October 7, 2014

**Re: Response to ADEQ Correspondence Dated September 23, 2014  
Area 1 Work Plan – September 2014  
Whirlpool Corporation  
Fort Smith, Arkansas  
EPA No. ARD042755389  
AFIN No. 66-00048  
CAO LIS 13-202**

**AREA 1 DETAIL**  
WHIRLPOOL FACILITY  
FORT SMITH, ARKANSAS

FIGURE  
1

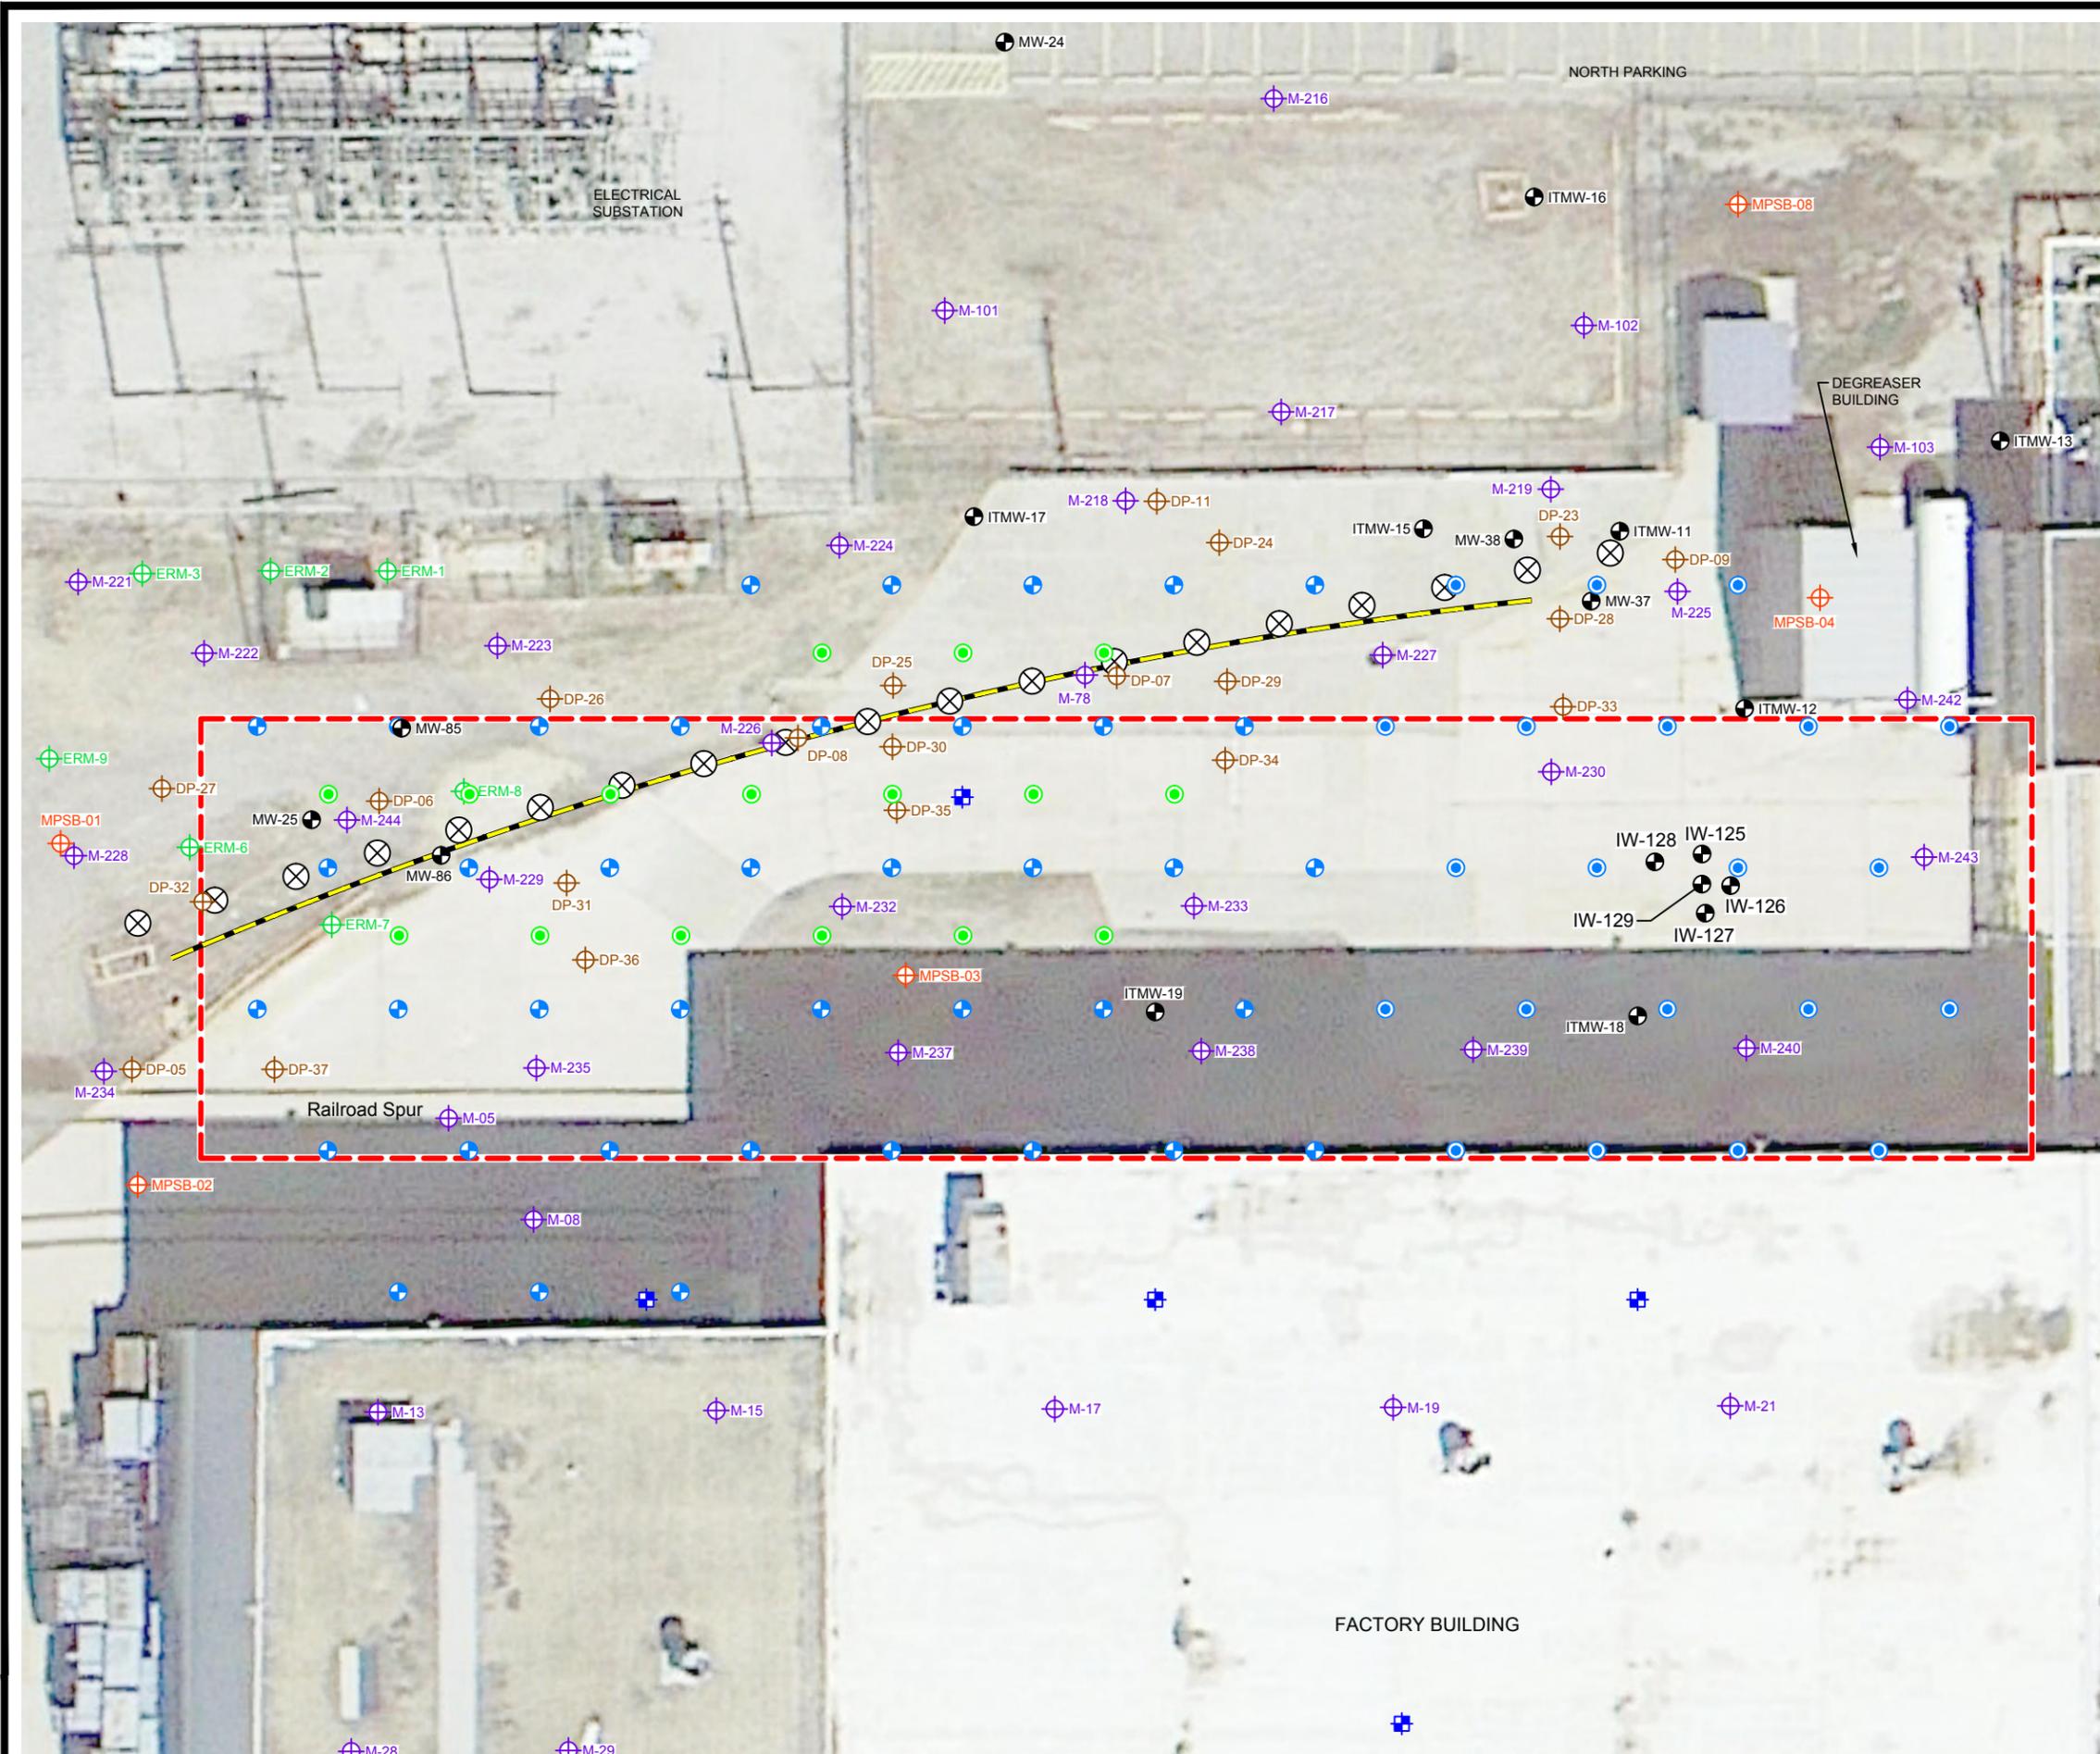
**4.2 Reagent Injection (1st paragraph, 1st sentence):** *Based on the results of the previous tracer and In-Situ Chemical Oxidation injections, it is apparent the groundwater flow in the Basal Transmissive Zone is controlled to some extent by the presence of preferential flow paths created by variations in depositional processes. Please describe what precautions will be taken during oxidant injection to minimize the channeling of oxidant to preferential pathways to avoid reducing the overall coverage of the Basal Transmissive Zone.*

successfully desorbed TCE from soils as indicated by the increase in TCE concentrations in groundwater samples from MW-25 and MW-85 (see attached tables) (the results of the second ISCO injection event will be compiled in the 2014 Third Quarter Progress Report). Based on these results, a supplemental MFR injection is proposed to facilitate further TCE desorption, followed by injection of BASP oxidant to treat TCE in groundwater. Therefore, the following injection activities will be performed in addition to those presented in the Area 1 Work Plan:

- Temporary Injection Points: Inject 50 to 200 gallons each of MFR into 16 additional temporary injection points, for a total of approximately 800 to 3,200 gallons of additional MFR solution.

The additional temporary injection points will be located in the western portion of Area 1 where higher TCE concentrations have been found in the Basal Transmissive Zone (see attached figure for location of additional temporary injection points). Actual locations may be modified based on field screening and analytical results from the new injection and monitoring wells installed according to the Area 1 Work Plan. Following MFR injection, BASP would be injected into the 40 injection wells and 21 temporary injection points as described in the Area 1 Work Plan. The injection of MFR is expected to promote the desorption or transfer of TCE and other contaminant of concern (COCs) from soil at areas outside of existing preferential groundwater flow paths. Treatment of the desorbed TCE would then occur via the subsequent BASP injection.
